CITY OF ALBUQUERQUE

Re: Kalm Brewery
8338 Comanche Rd NE
Traffic Circulation Layout
Engineer's/Architect's Stamp **01-04-18** (G19-D040)

DRAINAGE AND TRANSPORTATION INFORMATION SHEET (REV 11/2016)

TRAFFIC CIRCULATION LAYOUT

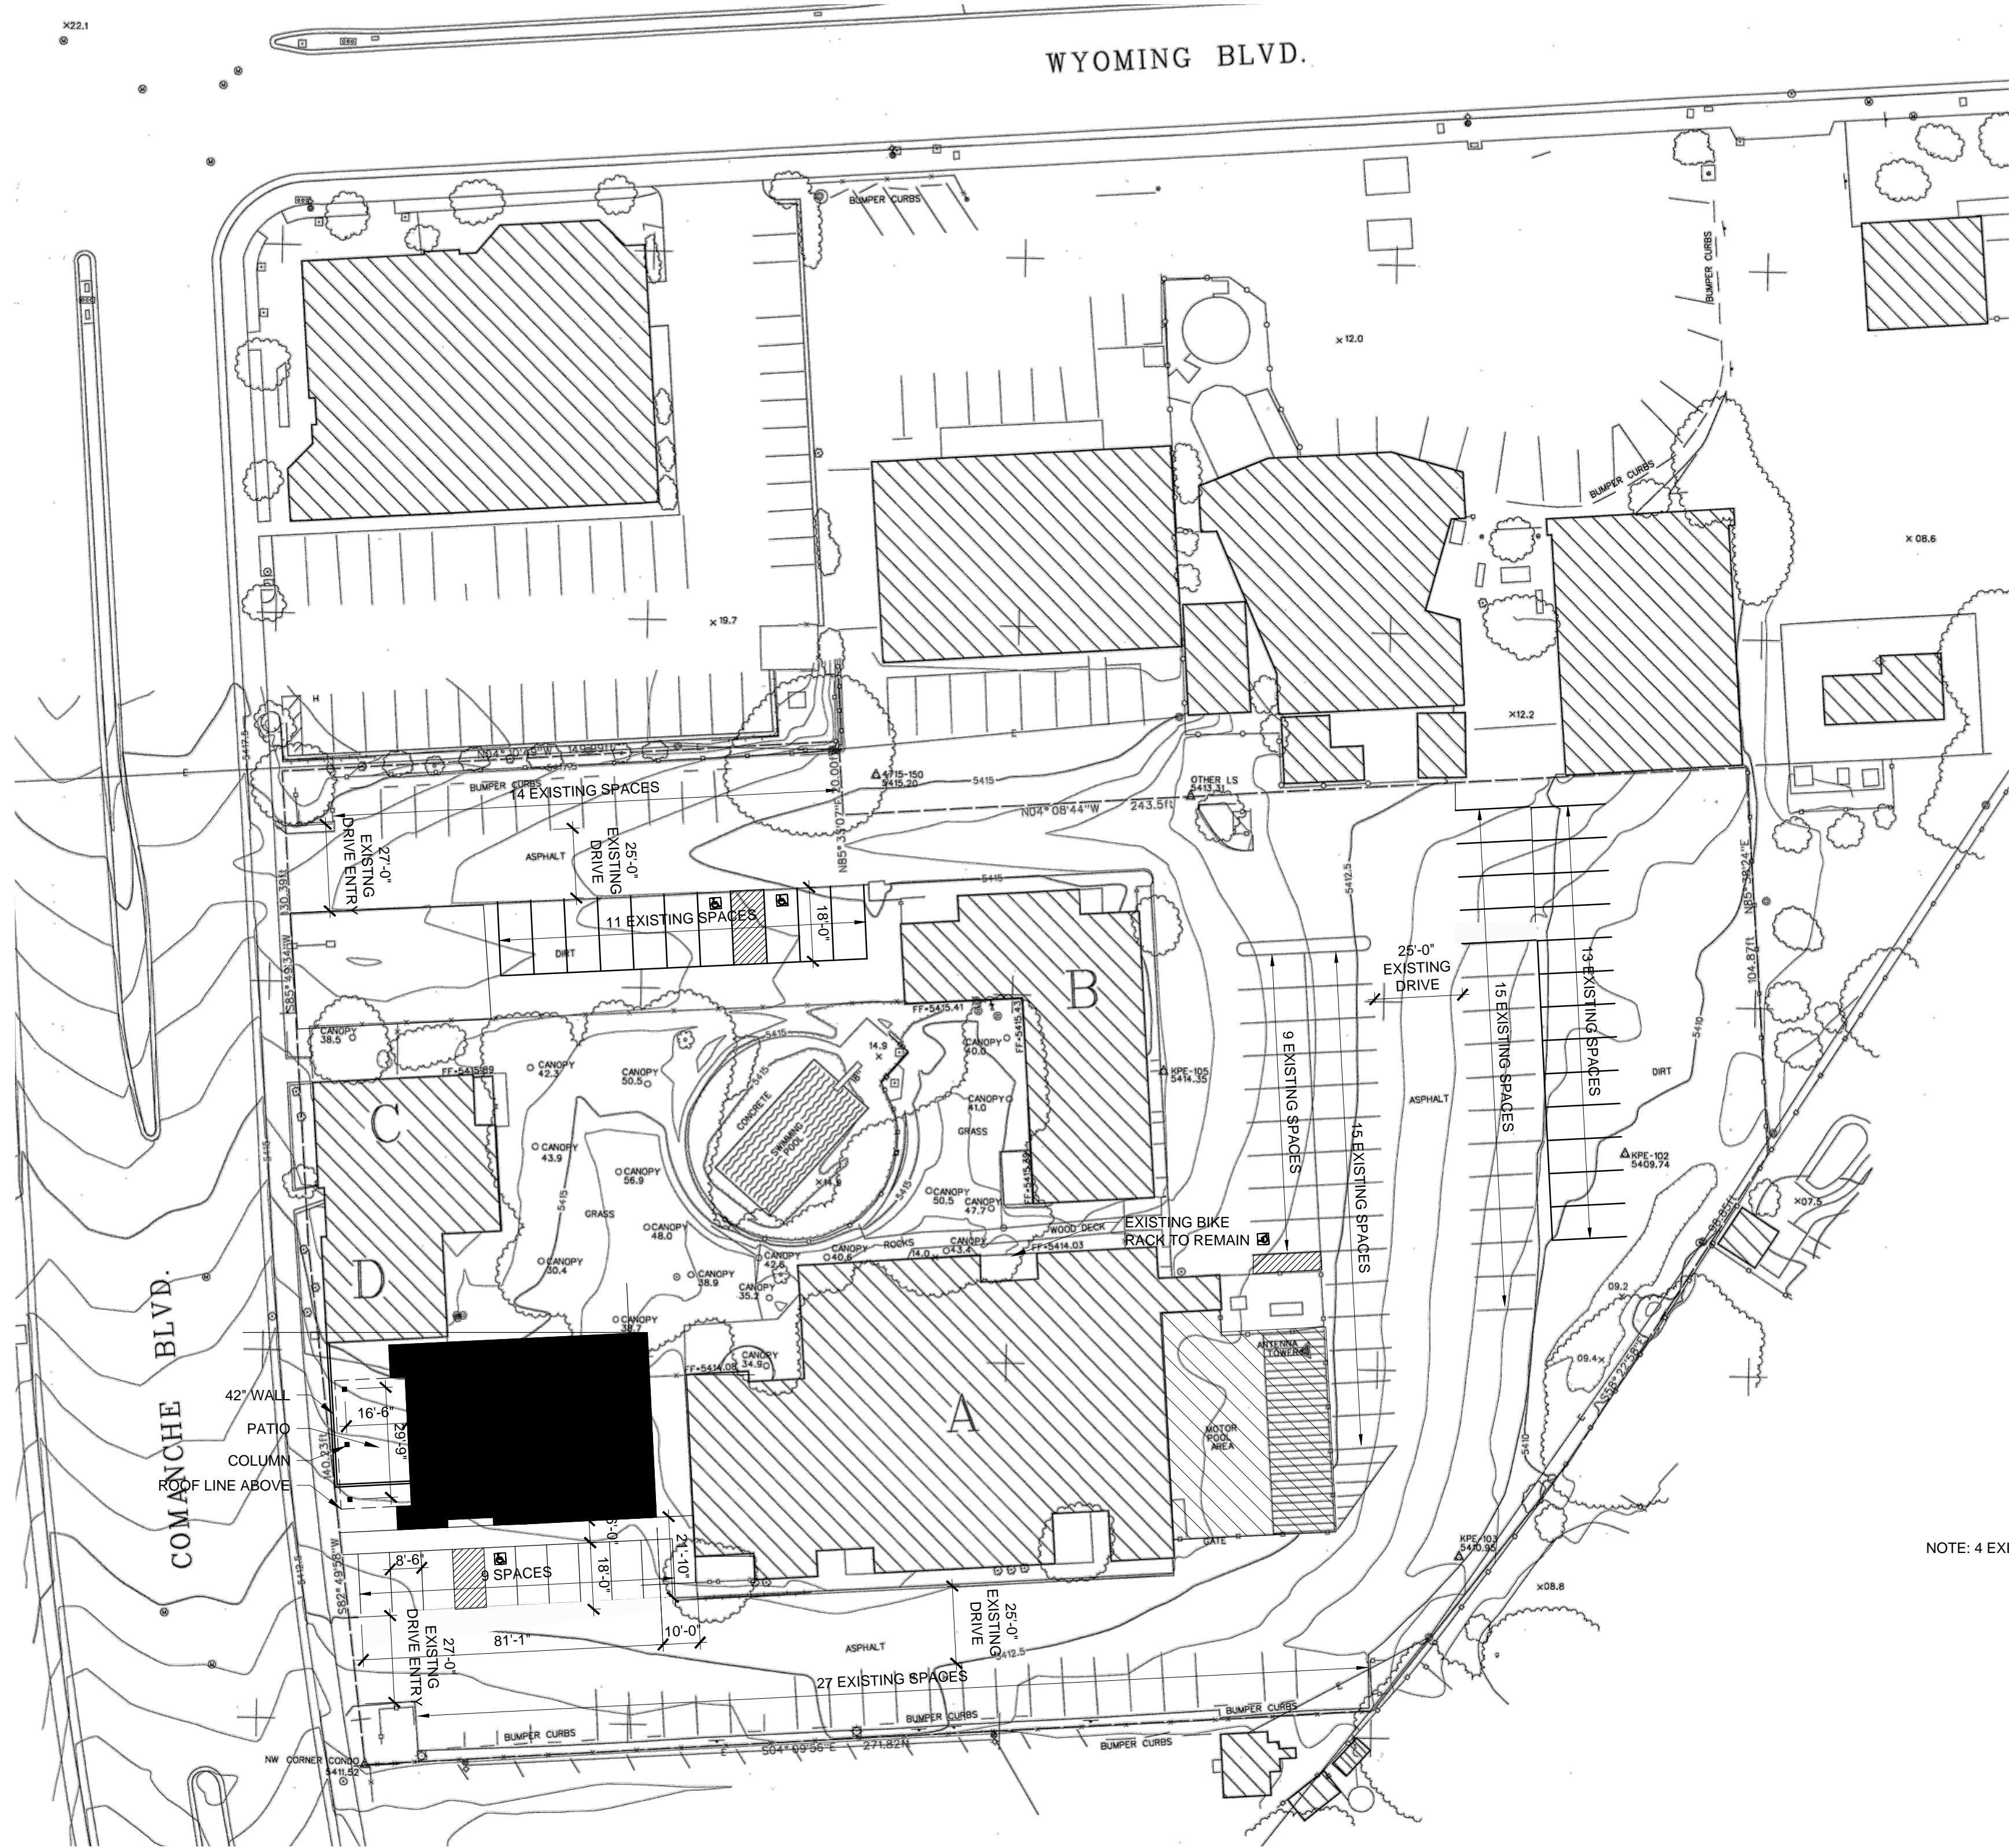
1. Please review and revise plan to provide all information listed on the attached Traffic Circulation Layout checklist.
2. Please refer to the attached Accessible Parking Checklist and revise the plan accordingly.

3. Please show a vicinity map showing the location of the development in relation to streets and well known landmarks.
4. List the number of accessible parking spaces required by the zoning code with the parking calculations.

5. A scale of 1"=20' is recommended for sites less than 5 acres.
6. Please remove the topo information and the adjacent parcels not related to the building permit.

7. Please identify all existing buildings, doors, structures, sidewalks, curbs, drive pads, wall and anything that influences the parking and circulation on the site.

8. Identify the right of way width, medians, curb cuts, and street widths on Comanche.
9. Clarify existing property lines and proposed property lines.
10. Please list the width and length for all existing and proposed parking spaces. Some dimensions are not shown.

11. The ADA accessible parking spaces must be updated to current ADA standards.
12. The ADA accessible parking sign must have the required language per 66-7-352.4C NMSA 1978 **"Violators Are Subject to a Fine and/or Towing."** Please call out detail and location of HC signs.

13. The ADA access aisles shall have the words **"NO PARKING"** in capital letters, each of which shall be at least one foot high and at least two inches wide, placed at the rear of the parking space so as to be close to where an adjacent vehicle's rear tire would be placed. (66-1-4.1.B NMSA 1978)

14. Motorcycle parking spaces shall be designated by its own conspicuously posted upright sign, either free-standing or wall mounted per the zoning code.

15. Show all drive aisle widths and radii. Some dimensions are not shown.
16. The parking spaces on the south end do not look to be useable. All spaces on the site plan must be present and functional, at final inspection.

17. List radii for all curves shown; for passenger vehicles, the minimum end island radius for passenger vehicles is 15 ft. Radius for delivery trucks, fire trucks, etc. is 25 ft. or larger.

18. Per the zoning code, a 6 ft. wide ADA accessible pedestrian pathway is required from the public sidewalk to the building entrances. Please clearly show this pathway and provide details.

19. Per DPM, a 6 ft. wide ADA accessible pedestrian pathway is required from the HC parking stall access aisles to the building entrances. Please clearly show this pathway and provide details.
